TRANS/WP.29/GRRF/2005/8  
19 November 2004

**AMENDMENT PROPOSAL TO REGULATION No. 13**

(Braking)

Transmitted by the expert from the European Association of Automotive Suppliers (CLEPA)

Diagram 1"

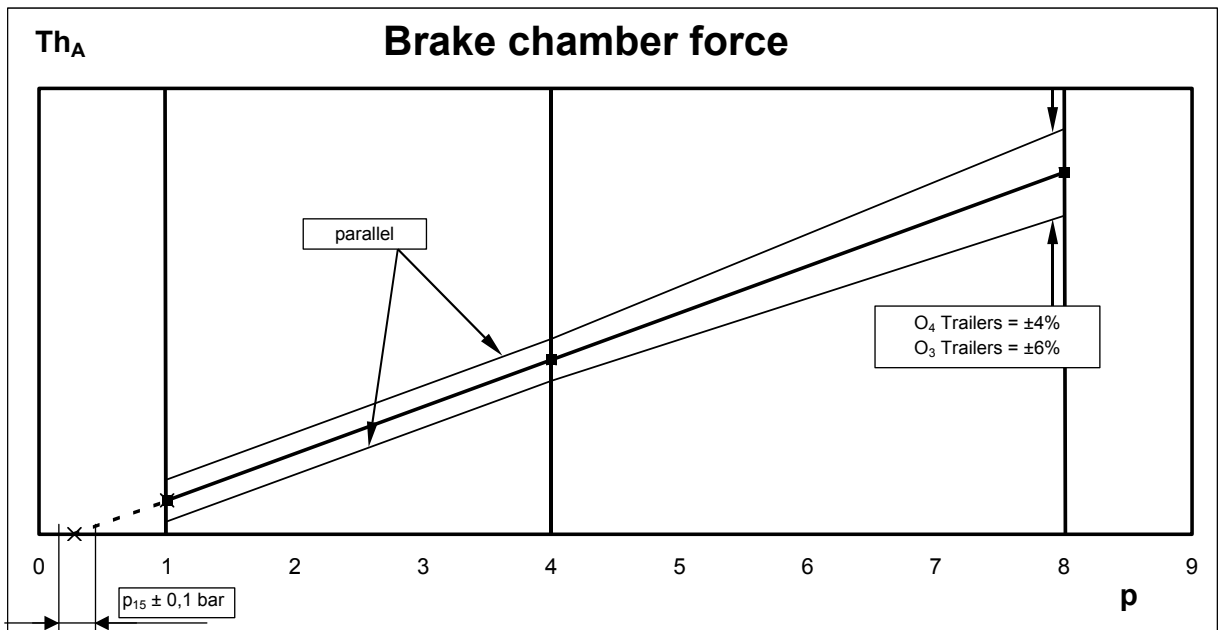
2.3.2. With respect to the verification of average thrust ( $Th_A$ ) -  $f(p)$ , a graph defining the acceptable performance variation shall be constructed following the model shown in Diagram 1, which is based on the manufacturers declared thrust to pressure relationship. The manufacturer shall also define the category of trailer for which the brake chamber may be used and the corresponding tolerance band applied."

To overcome this problem, it is proposed that the tolerance band applied to the manufacturers declared performance is constructed in a way that at pressures  $\geq 4.0$  bar the current +/- 4 per cent tolerance remains unchanged. The tolerance band from 4.0 bar to 1 bar would then be parallel based on the force difference determined at 4.0 bar. This tolerance band would be applied to brake chambers that may be installed on trailers of category O<sub>4</sub>, which generally utilize the larger size of brake chamber. In the case of O<sub>3</sub> trailers, where the use of smaller brake chambers is common, a larger tolerance is required. In this case, it is proposed that the above defined tolerance band has a tolerance of +/- 6 per cent.
